SUBMISSION ON AN APPLICATION FOR APPROVAL UNDER THE FAST-TRACK APPROVALS ACT 2024

Project: Northwest Rapid Transit (NWRT) Project

Relevant Plans/Documents: NWRT-00-00-EN-DRW-1106 & NWRT-00-00-EN-DRW-1106a

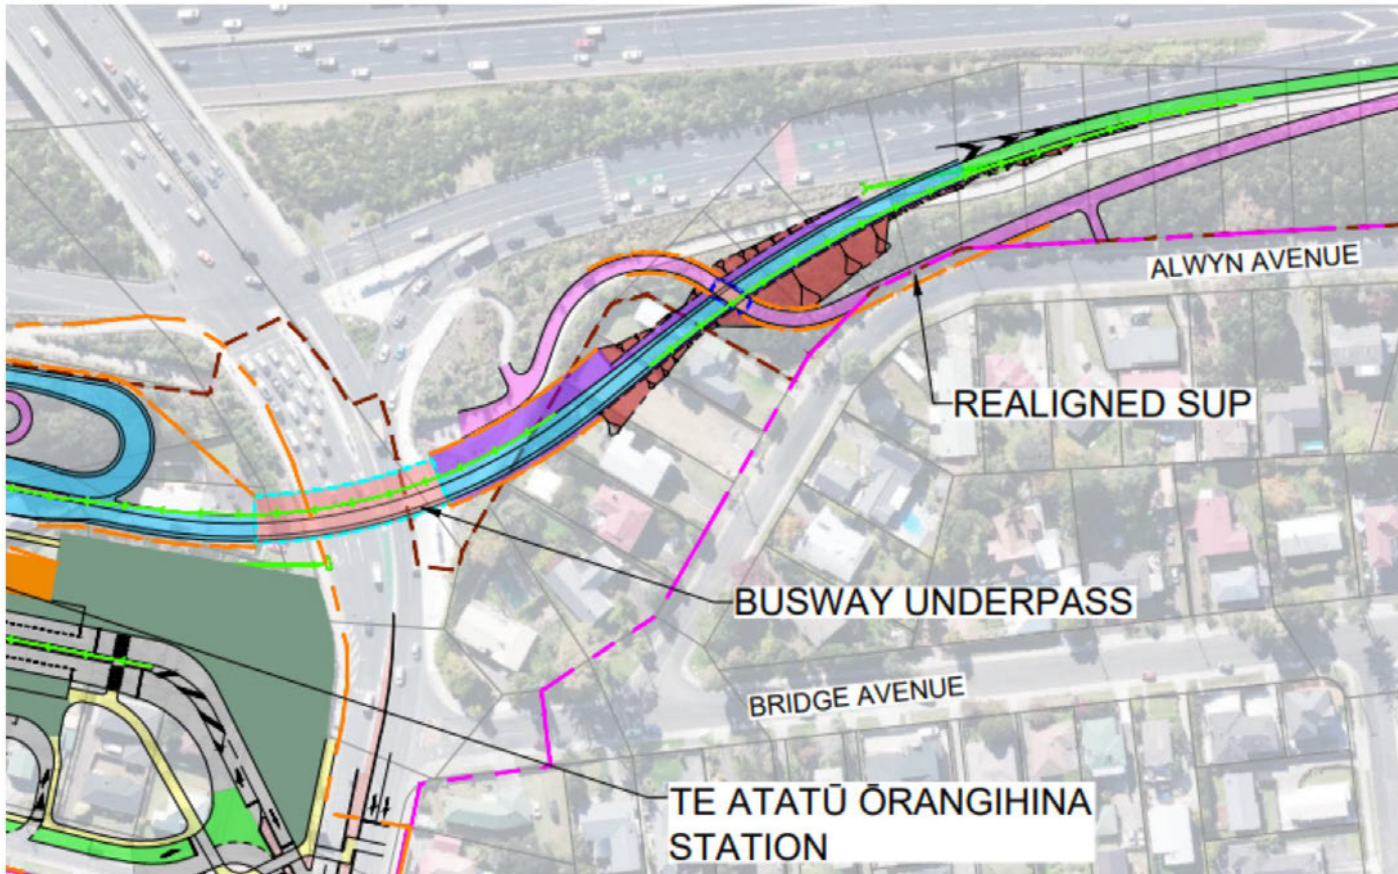
I strongly oppose the proposed pedestrian access linking the transit corridor directly into Alwyn Avenue.

I strongly oppose the removal of the existing earth bund adjacent to Alwyn Avenue.

I also oppose the proposed cycleway realignment requiring removal of existing bund material, vegetation, flora, and fauna.

Concerns are also raised regarding the apparent omission of the required Cut Batter within the relevant scheme drawings. Given the substantial height of the existing bund in this location, it appears evident that significant earthworks would be necessary to achieve acceptable pedestrian and cycling gradients.

1. Decline the proposed pedestrian access connection into Alwyn Avenue.
2. Require retention of the existing earth bund and associated vegetation.
3. Reject the proposed cycleway realignment and retain the existing alignment.
4. Require further assessment of parking, traffic safety, visibility, and CPTED impacts associated with the proposal.
5. Recognise the cumulative adverse effects already experienced by residents of Alwyn Avenue and avoid further unnecessary residential intrusion.
